R09PH

SUBJECT: RECALL R09PH POWER STEERING RESERVOIR GASKET FAILURE

Power Steering Reservoir Gasket

MODELS AFFECTED: 2009-2010 BBCV Visions and all 2008 BBCV Visions serviced under bulletin, S07MU Power Steering Reservoir Cap

Square and tighten

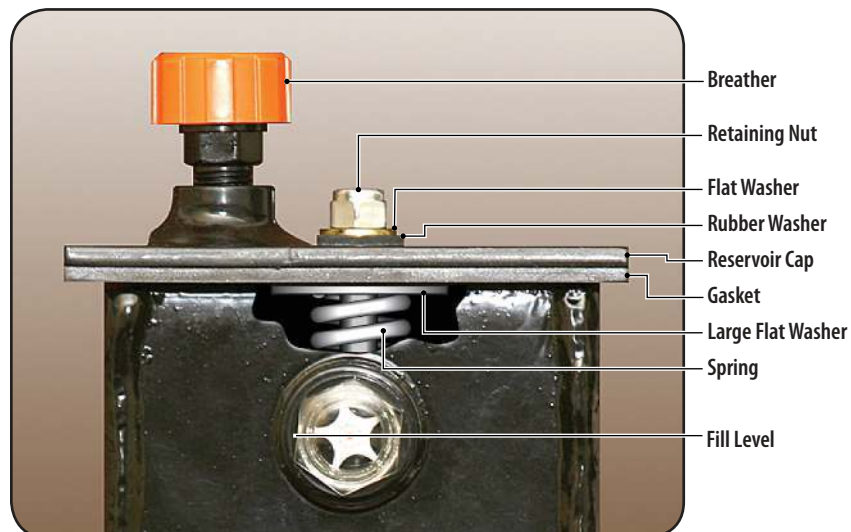
11 Place the side of the new gasket with the printed surface next to the cap and align the holes in the gasket with the holes in the cap.

12 Place the new assembly back onto the reservoir stud, squaring the sides of the cap and gasket to the sides of the reservoir.

13 While pressing the cap down against the spring, install the new small rubber washer and the small flat washer removed in Step 4.

14 Install the retaining nut onto the stud and tighten while holding the cap and gasket square to the reservoir. Torque the retaining nut to 10 ft. lbs.
